TECHNICAL SERVICE BULLETIN

TSB #: 12-001 **Job Code:** 9801138 **Flat Rate:** 0.25 hour

Remove and replace slide out fuses to the configuration listed below

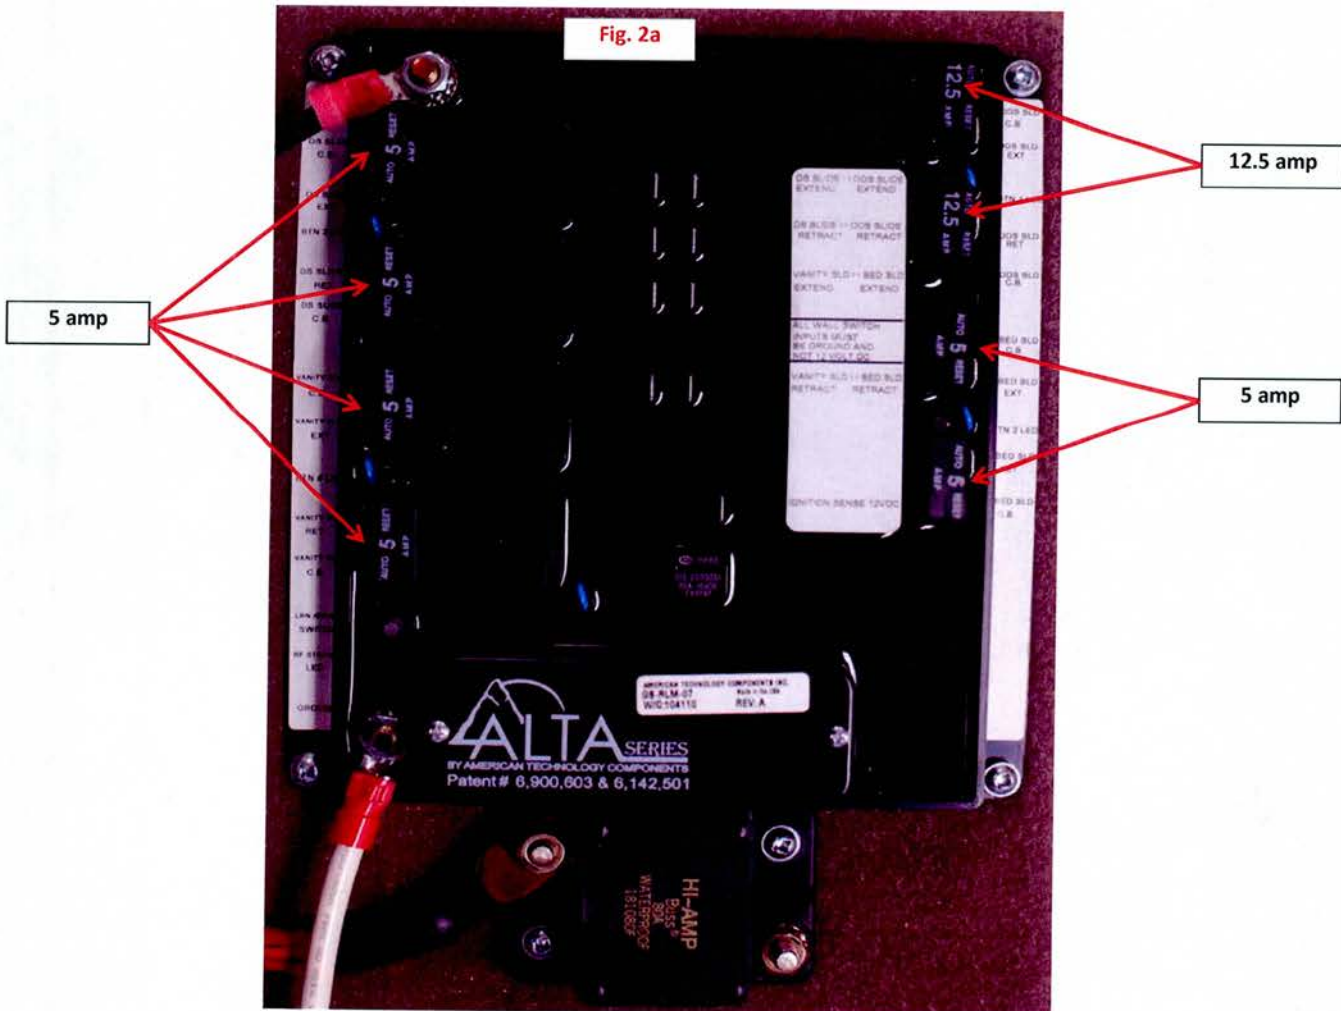
1. Locate the slide out fuse panel in the front (driver side) exterior compartment (fenderskirt).
2. Using the needle nose pliers, remove the existing fuses and replace them with the new fuses in the order listed in **Figure 2a**.

- (2) labels
- (2) 12.5 amp fuse
- (6) 5 amp fuse
- Instruction sheet
